# Non-Conformance Report

Report No.	Date	Project
1	11/20/2018	Antrim Wind Project

Antrim NH Wind: Culvert SD-4: Box culvert stability and streambed  
Non-conformance analysis and report

Conformance Plan: SD-4 Box Culvert

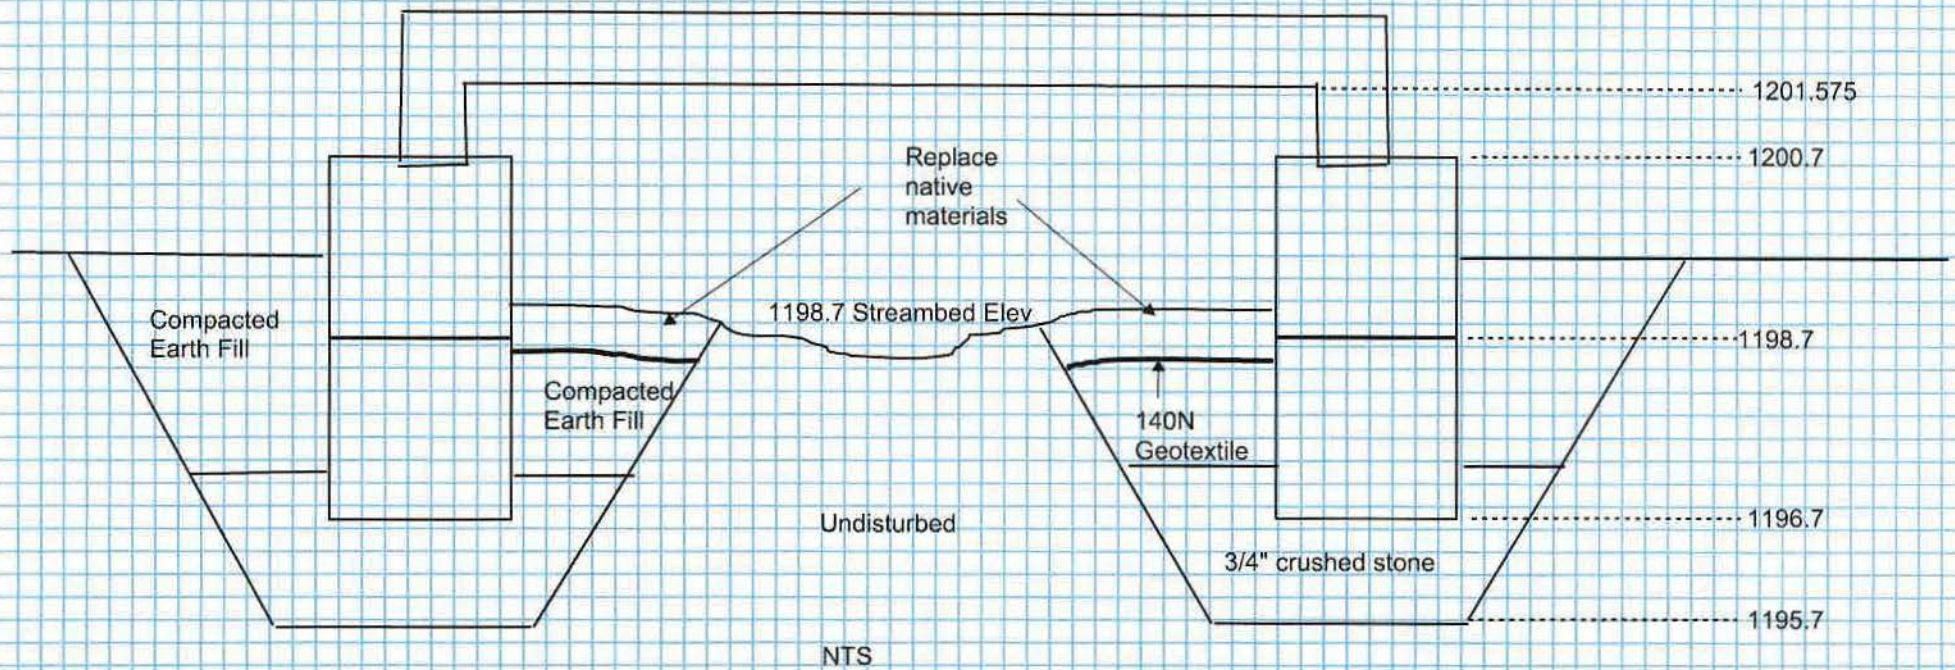
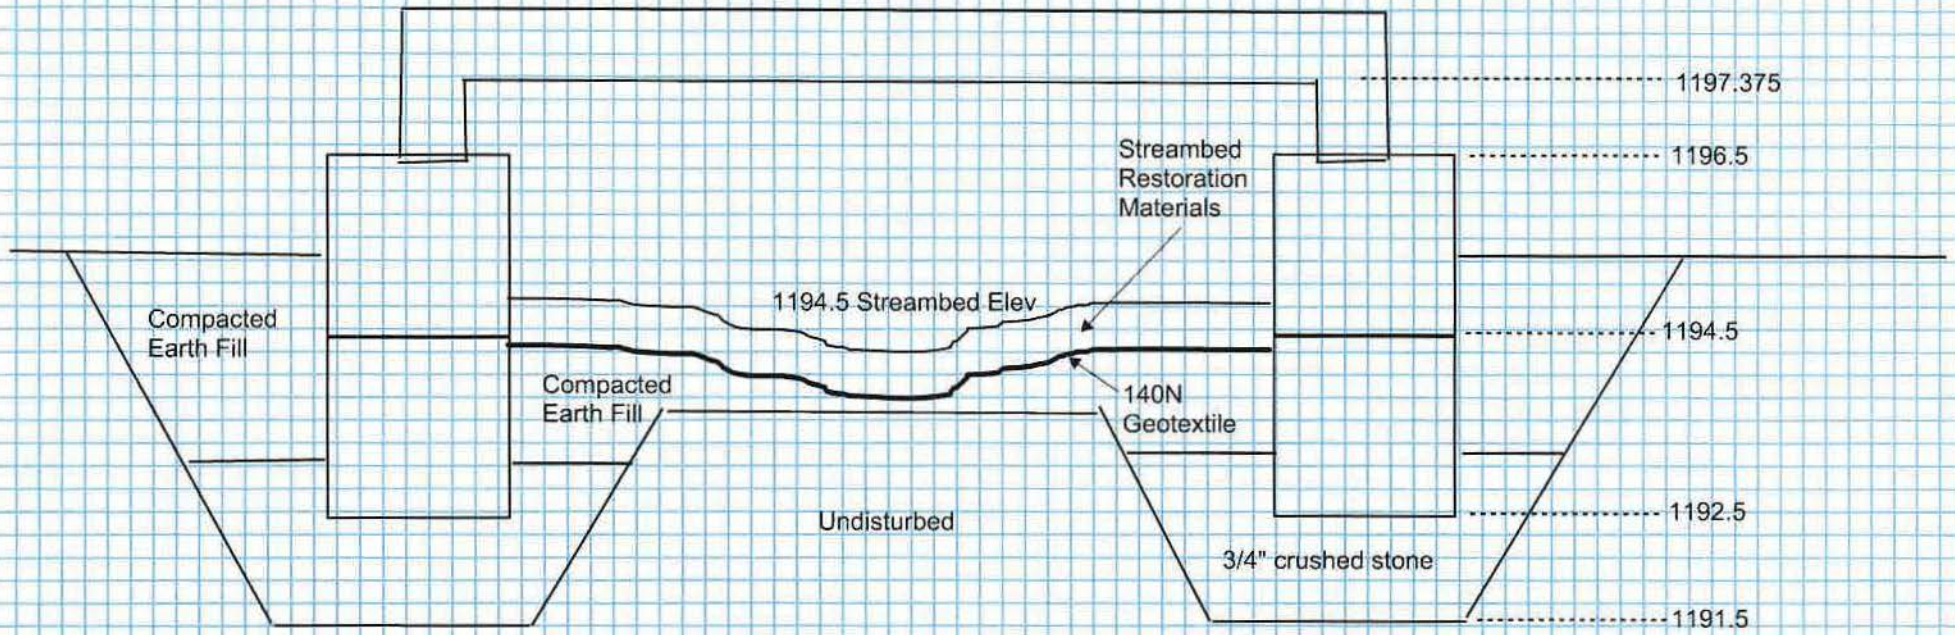
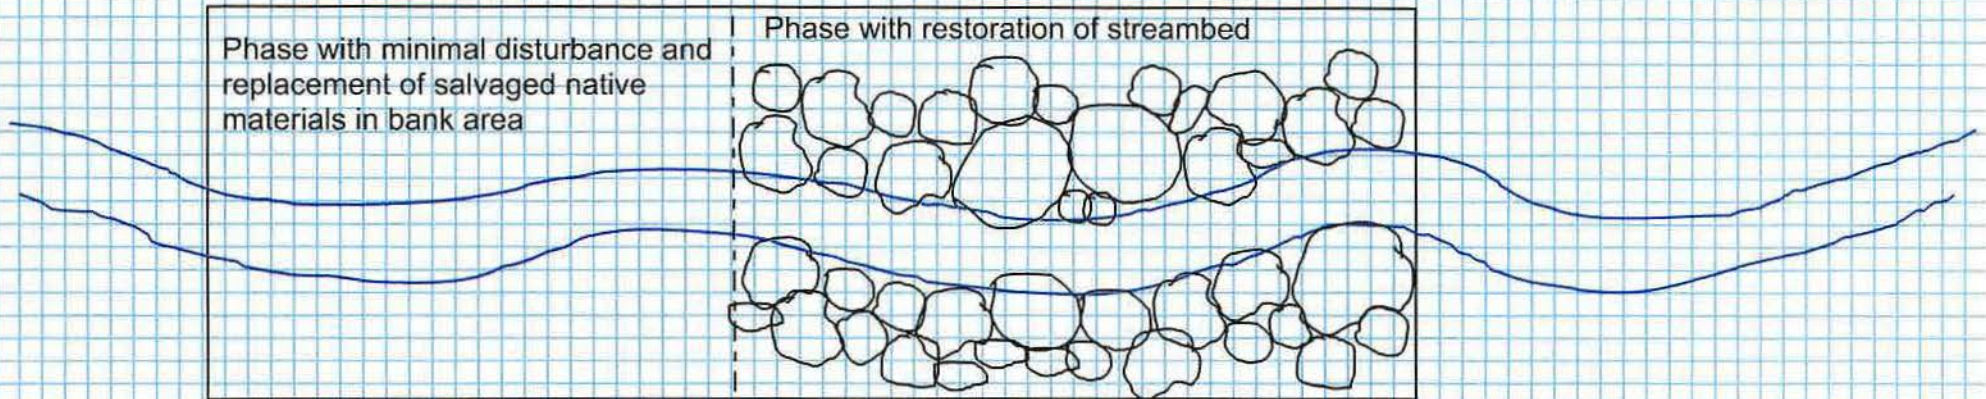
To address the non-conformance issues, Sargent proposes to increase the footer depth with a second course of footer blocks, isolate the footer bedding from stream flow, and re-establish to mimic the natural streambed. See attached "Conformance Plan" for details of this plan.

The revised installation will prevent the flow of water under the footings and will provide a streambed mimicking that of a natural stream.

The installed components and temporary streambed materials will be removed. Additional depth of excavation will be done for the additional course of footers. The footers will be bedded on  $\frac{3}{4}$ " crushed stone. Native earth materials will be used to backfill above the  $\frac{3}{4}$ " crushed stone on both the interior and exterior of the footers. This fill will be compacted.

The streambed will be shaped with a slight depression near the middle for low flow. Geotextile fabric (140N) will be placed over the compacted earth fills.

For the streambed, onsite materials will be used as much as possible. The streambed will be created by placing native rocks (approximately 1' – 2' in size) salvaged from on-site and chinking them in place with a 1.5" to 3.5" deep layer of stone such as Dirt Doctors NH Riverbed 1 ½" to 2" stone. The material placement will be done to match existing streambed elevations. The placement of the larger rocks will be done to mimic the nature of the stream just upstream and downstream from the work area, excluding placement of any boulders so large as to pose a problem in the constrained area in the culvert.

Summit Geoengineering has reviewed the attached sketch and this plan and commented "This is a sound concept. This approach will provide a stable base for the abutment blocks and will also provide sufficient scour protection."

BOX CULVERT

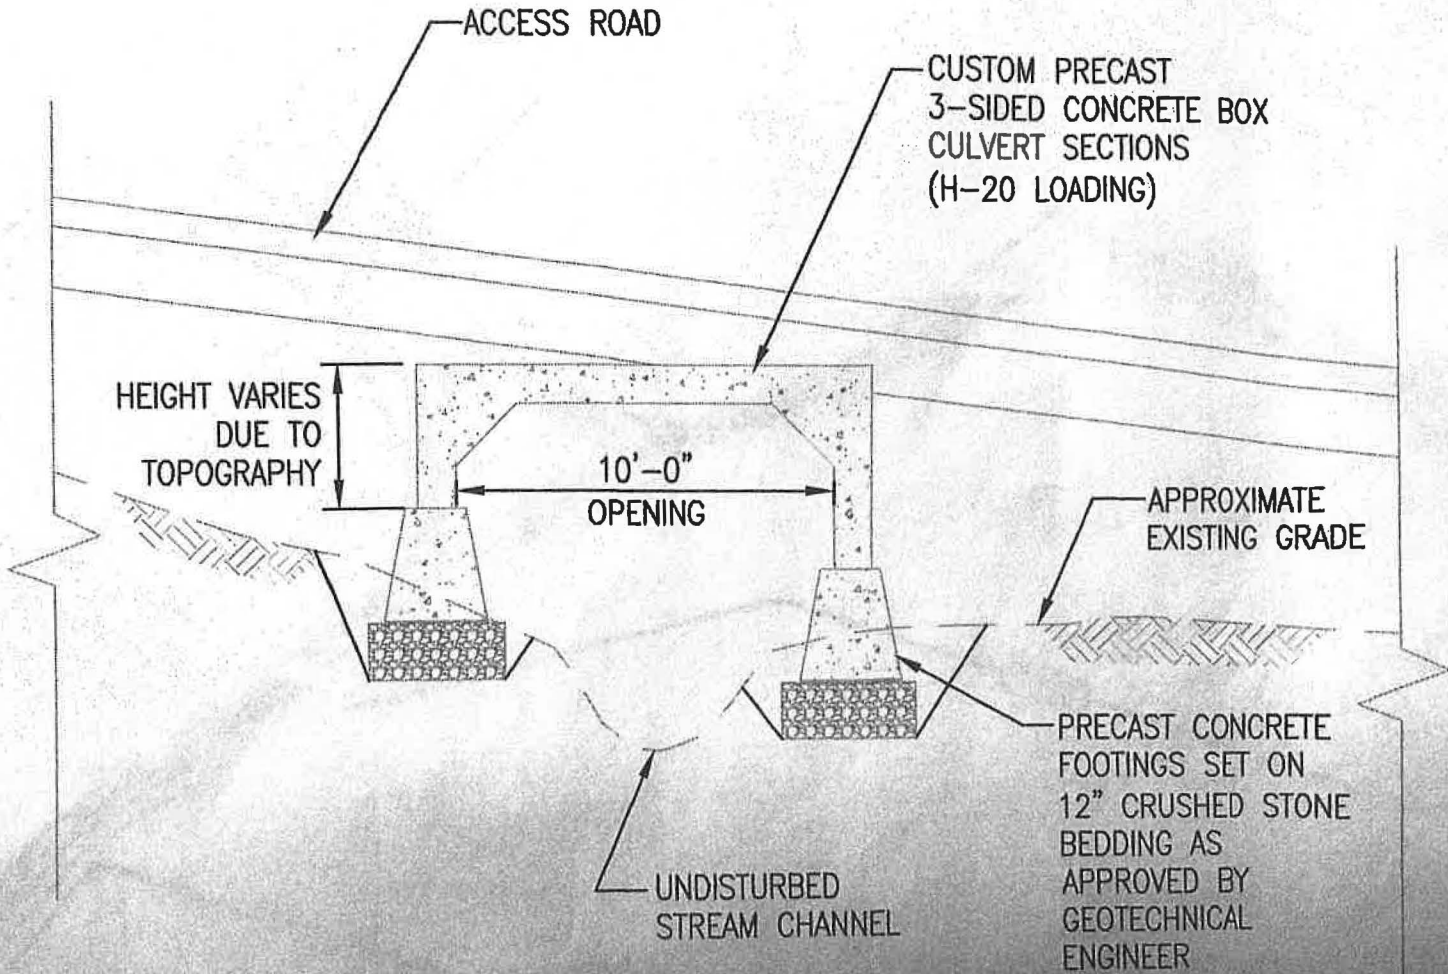
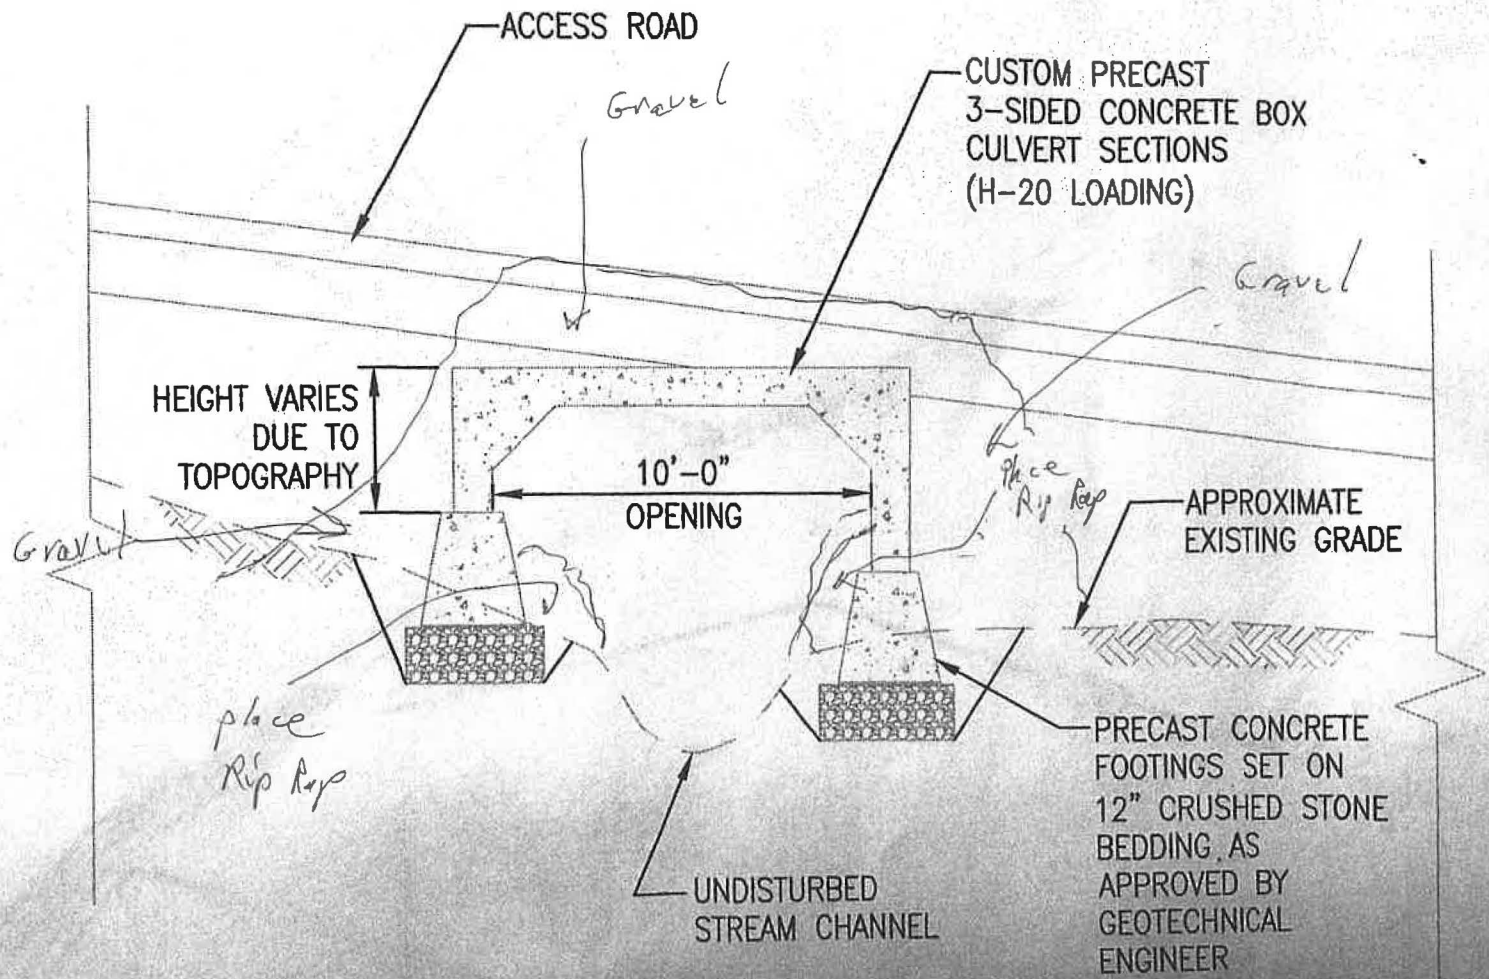
The details on sheet C-08 of the IFC set show culvert SD-4 as a 3-sided box culvert with an undisturbed stream channel. During the installation of the first 20 ft of the culvert, the stream bed was excavated, graded, and replaced with stone. (See attached Photo)

Antrim NH Wind  
Conformance Plan: SD-4 Box Culvert

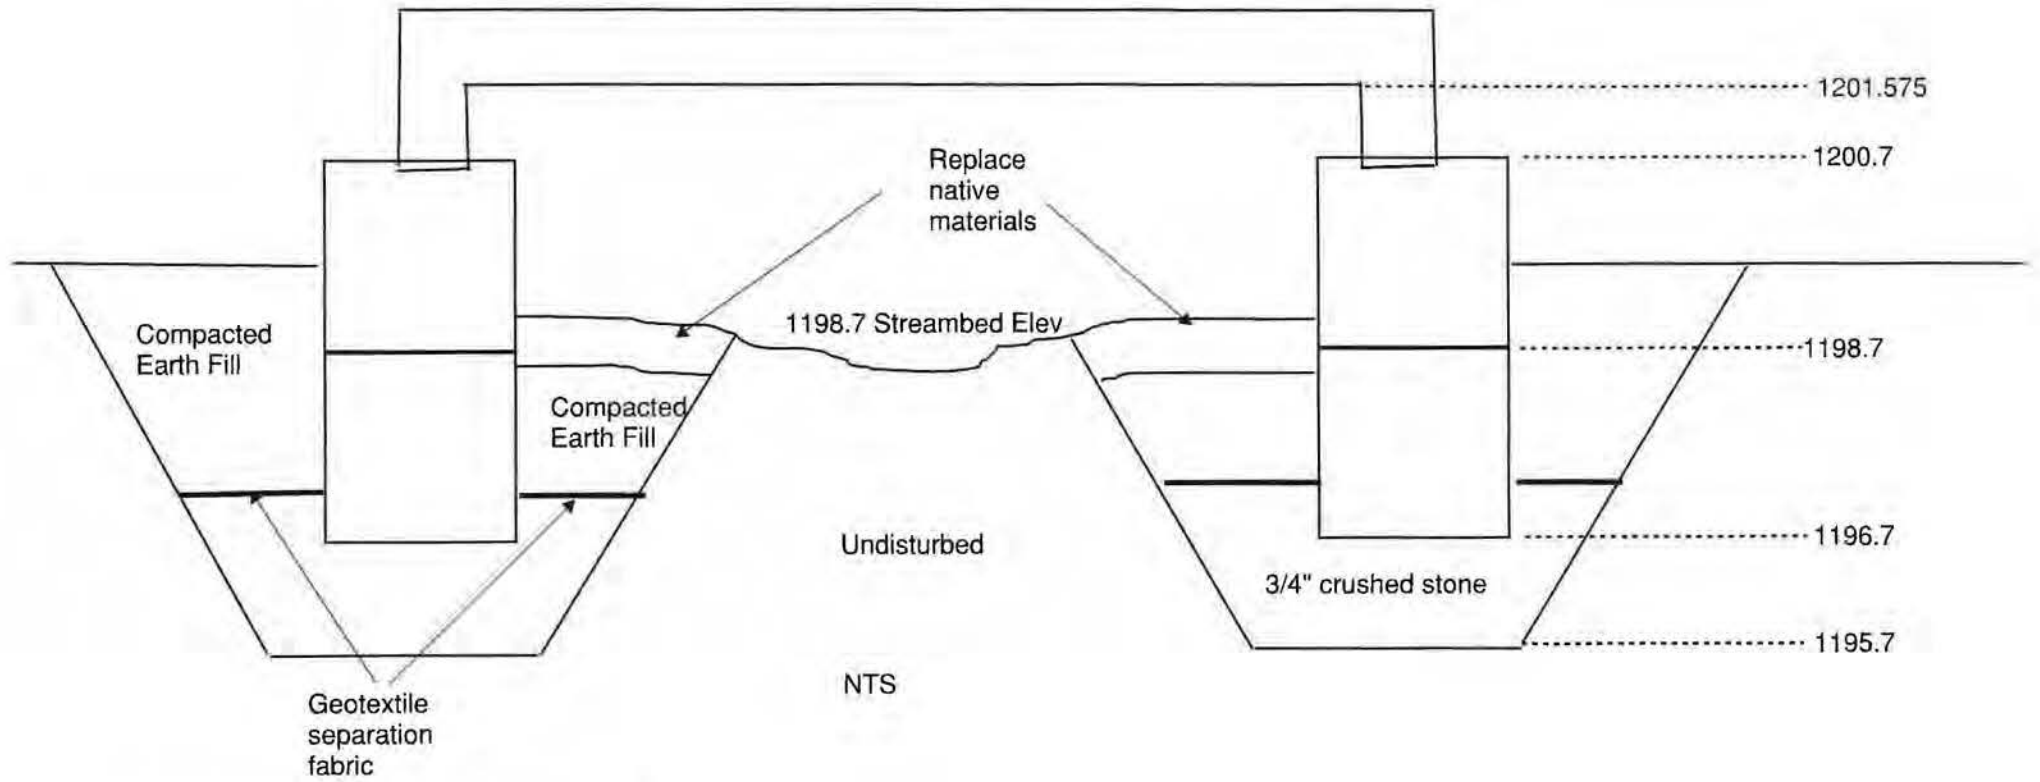
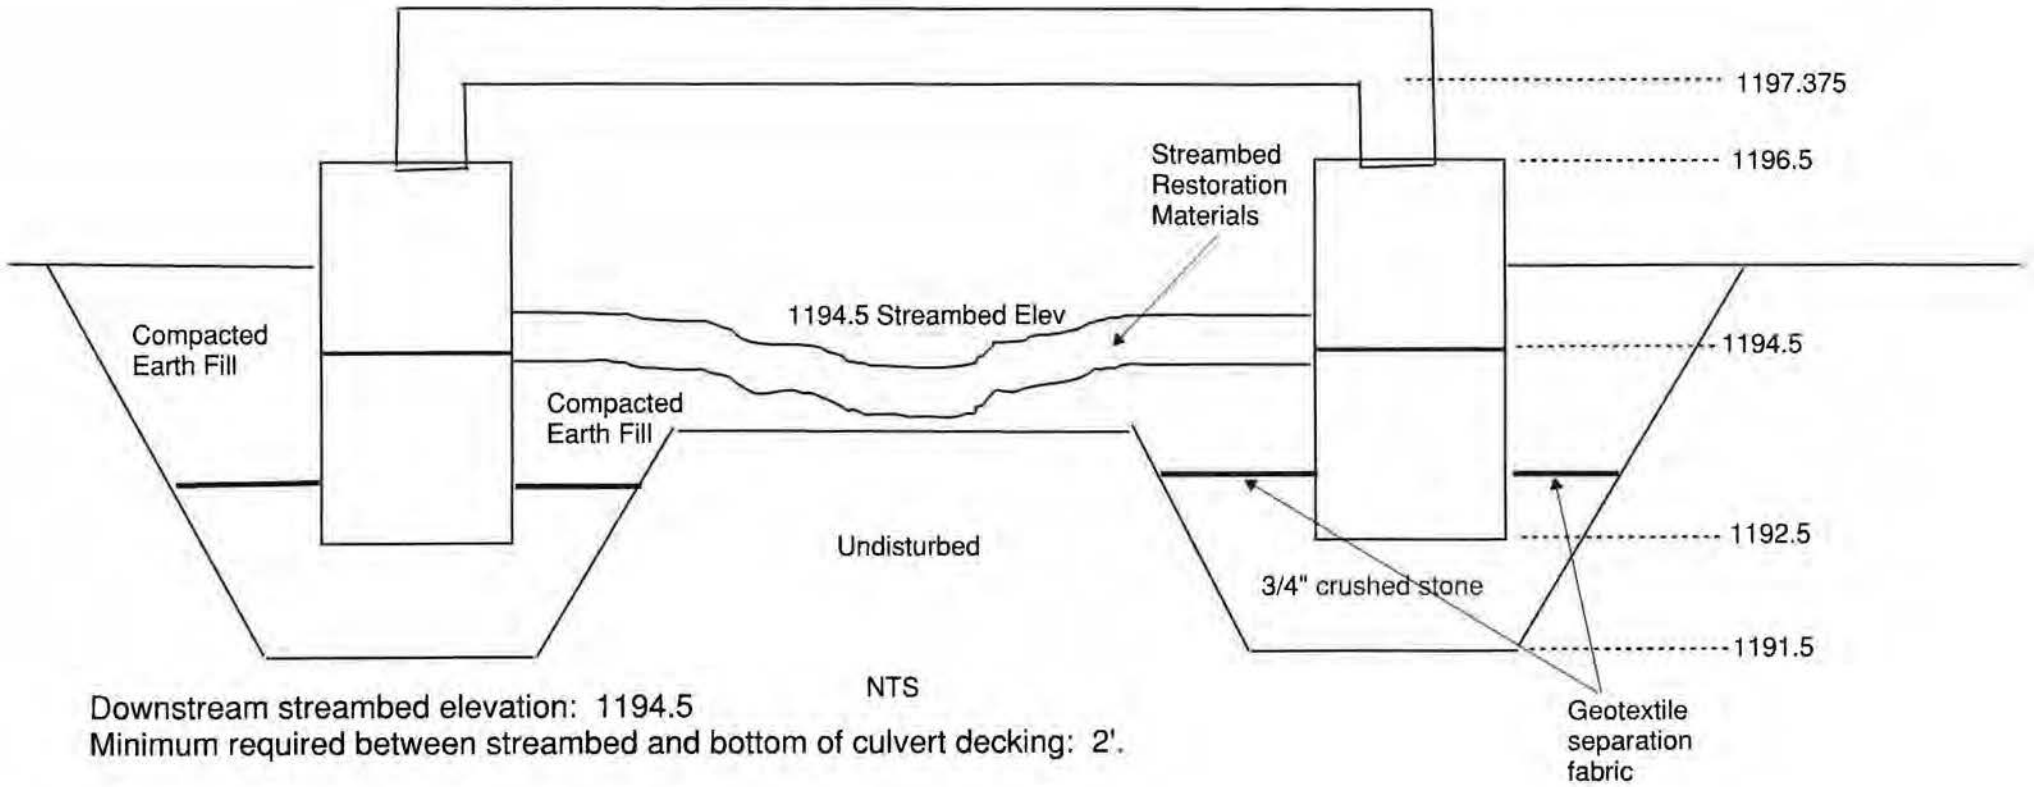
The installed components and temporary streambed materials will be removed. Additional depth of excavation will be done for the additional course of footers. The footers will be bedded on ¾" crushed stone. A geotextile separation layer will be placed on the ¾" crushed stone. Native earth materials will be used to

backfill above the fabric on both the interior and exterior of the footers. This fill will be compacted.

The streambed will be shaped with a slight depression near the middle for low flow. No geotextiles will be used above the compacted earth fills.

The streambed will be created by placing the streambed material mix on the shaped compacted bed while maintaining the low flow channel. The mix will be placed the full width of the interior. The placement of the larger boulders may be adjusted after initial placement. The mix will then be hosed down to wash the finer materials downward. The material placement will be done to match existing streambed elevations. The placement of the mix will be done to mimic the nature of the stream just upstream and downstream from the work area, excluding placement of any boulders so large as to pose a problem in the constrained area in the culvert.

The footers will be bedded on  $\frac{3}{4}$ " crushed stone. A geotextile separation layer will be placed on the  $\frac{3}{4}$ " crushed stone. Native earth materials will be used to backfill above the fabric on both the interior and exterior of the footers. This fill will be compacted. No geotextile fabric will be used above the compacted earth fill. In the interior, above the compacted fill, salvaged excavation material will be placed. The bridge decking will then be placed.

Based on our review of this information, photographs of the construction, and phone conversations with you, it is our opinion that this approach will provide a stable base for the abutment blocks and will also provide sufficient scour protection. Evaluation of the streambed restoration is beyond our expertise.

The revised Conformance Plan has been reviewed and it incorporates the stream bed restoration method that was discussed Tuesday during the NHDES site visit. Placement of geotextile fabric only along the base of the footers, below the compacted earth fill and at the depth indicated on the plans, is a reasonable modification of the original plan. It is unlikely that the fabric would become exposed at this depth.

The updated Conformance Plan, as received on December 21, 2018, is acceptable.
